PROPOSED DRAFT GLOBAL TECHNICAL REGULATION (GTR)
on
PEDESTRIAN PROTECTION.

This document is a working document circulated for discussion and comments. It is only submitted with the intention to facilitate discussion by the GRSP Informal Group.

GLOBAL TECHNICAL REGULATION NO. Y

Figure 13a: windscreen rear reference line

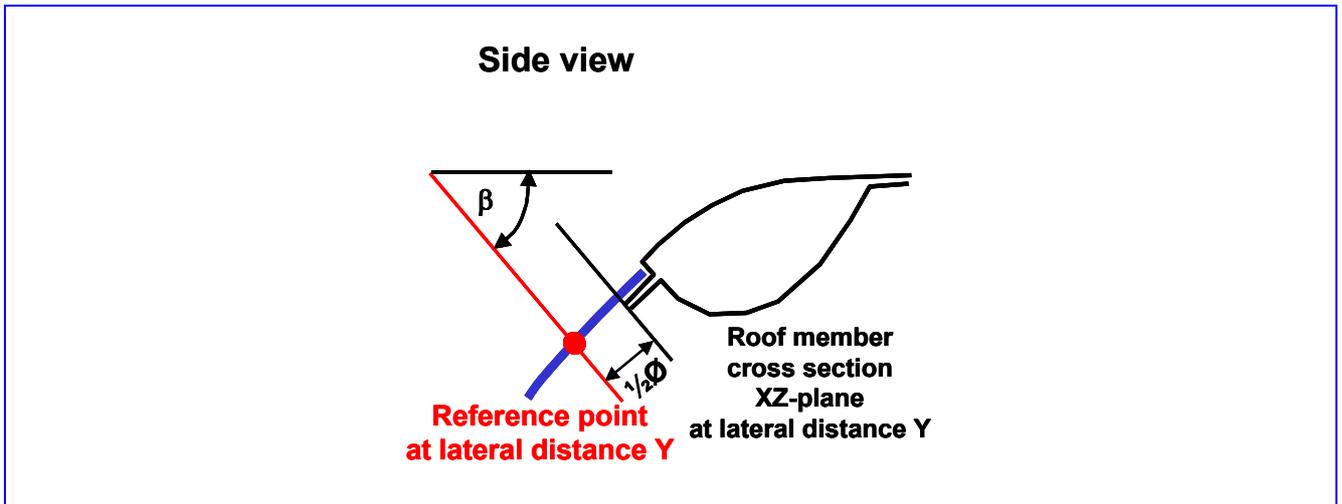
- ~~————— **TO BE WORDED**, see Figure 13a.
————— *OICA comment: preliminary agreed on 6. GTR meeting.*
~~**EU Comment:** This definition and those of 3.34 and 3.35 indeed require more discussion and agreement.~~~~

EU Comment: This diagram requires more discussion and agreement.

Figure 13b: windscreen side reference line

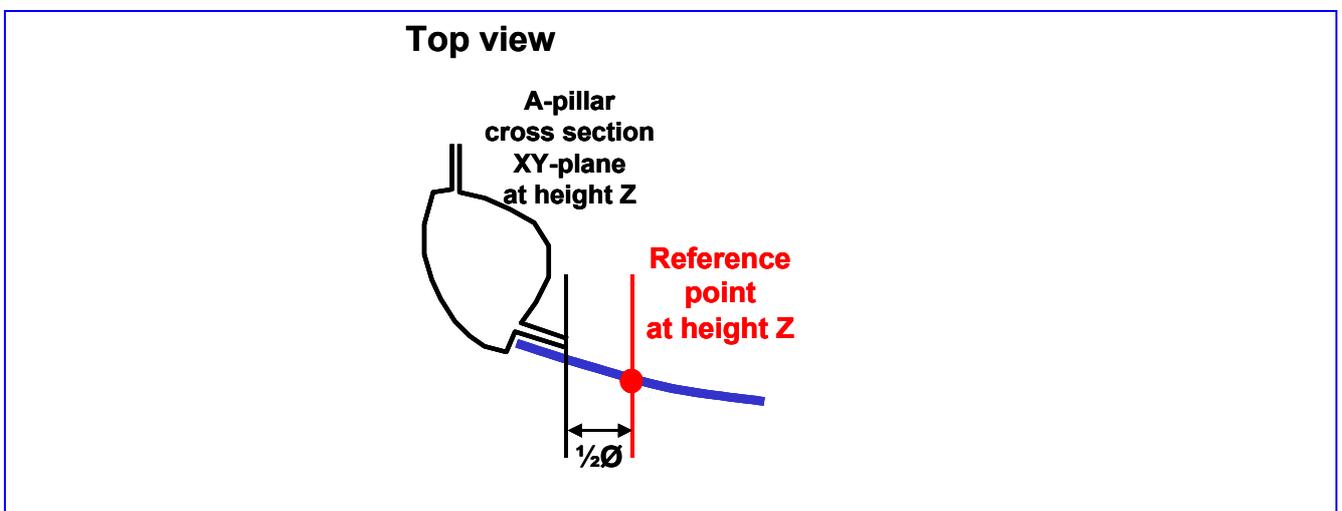
~~EU Comment: This definition and those of 3.23 and 3.35 indeed require more discussion and agreement.~~

EU Comment: This diagram requires more discussion and agreement.

Figure 13c: windscreen lower reference line

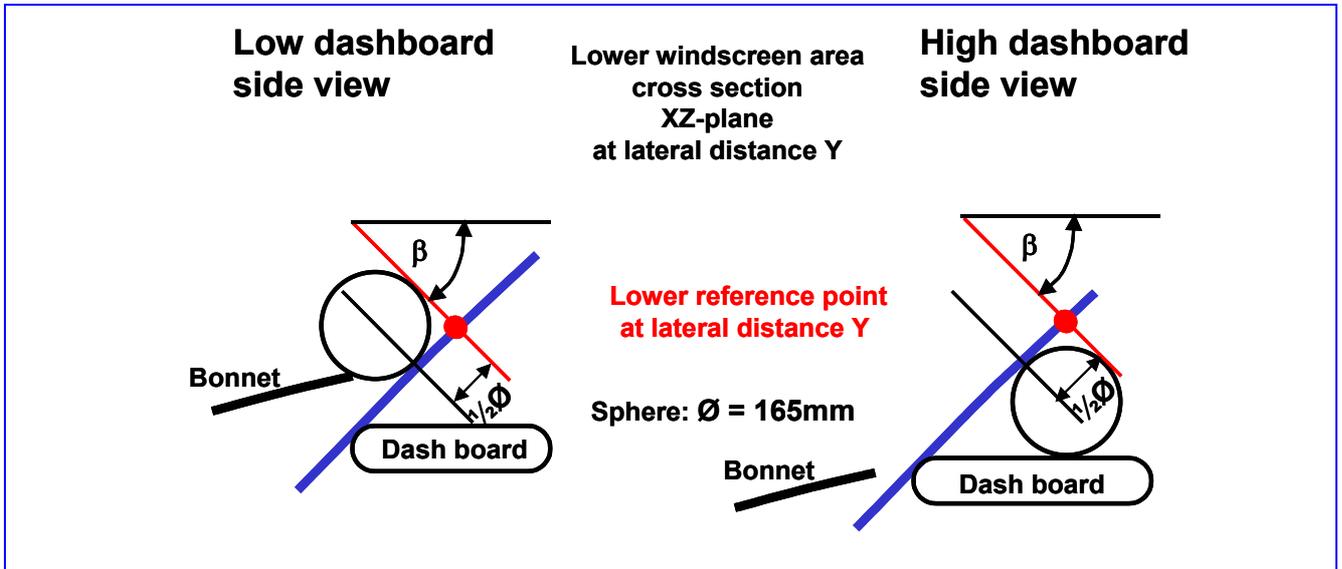
~~EU Comment: This definition and those of 3.23 and 3.34 indeed require more discussion and agreement.~~

EU Comment: This diagram requires more discussion and agreement.
